# Satellite Earth Station Licences

Amazon Kuiper Services Europe SARL and  
Starlink Internet Services Limited

## Information Notice

**Reference:** ComReg 25/79

*Figure 1. Results of the evaluation of the uplink EPFD in the Ka-band using an aggregate database based on the combined filings from Amazon's NGSO system.*

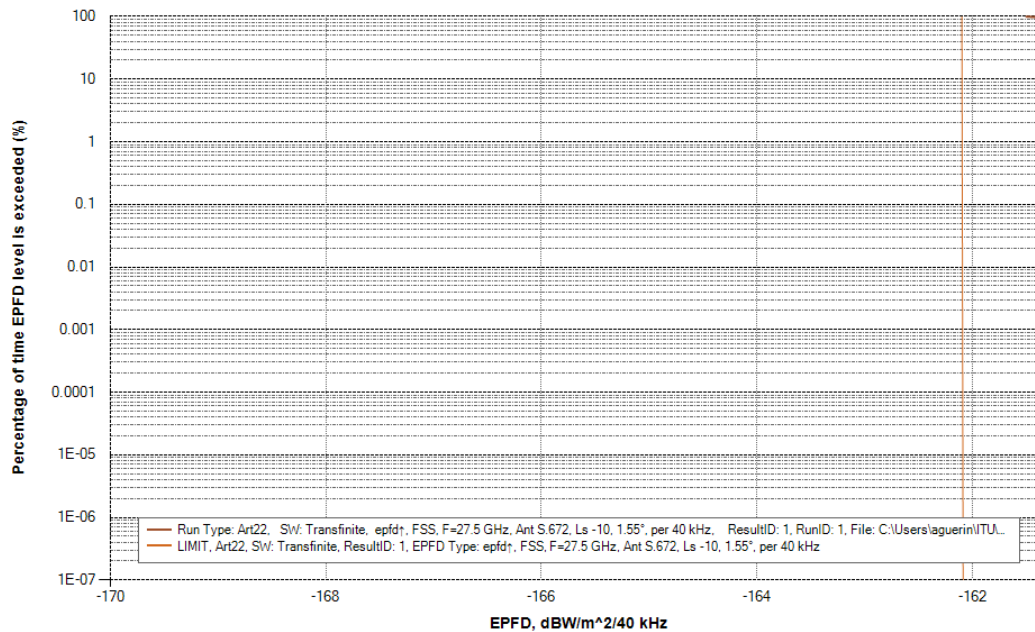
For the case at hand. Viasat conducted an initial evaluation of uplink EPFD in the Ka-band using an aggregate database based on the combined filings from Amazon’s NGSO system (USASAT-NGSO-8A, USASAT-NGSO-8B, USASAT-NGSO-8C). This was done using the ITU EPFD approved software without making any changes to the input parameters for the EPFD calculation, such as the number of co-frequency satellites, minimum elevation, and GSO arc avoidance. The results of this evaluation indicate that the EPFD limits would be exceeded, as illustrated in the Figure 1.

Given these preliminary results, which indicate that the Kuiper NGSO system would *not* comply with applicable EPFD limits, it is appropriate and imperative for ComReg to evaluate compliance with the EPFD limits as part of the application process. Without an independent EPFD assessment from ComReg, there is no basis for expecting that Amazon will comply with the limits in Article 22 of the Radio Regulations in Ireland.
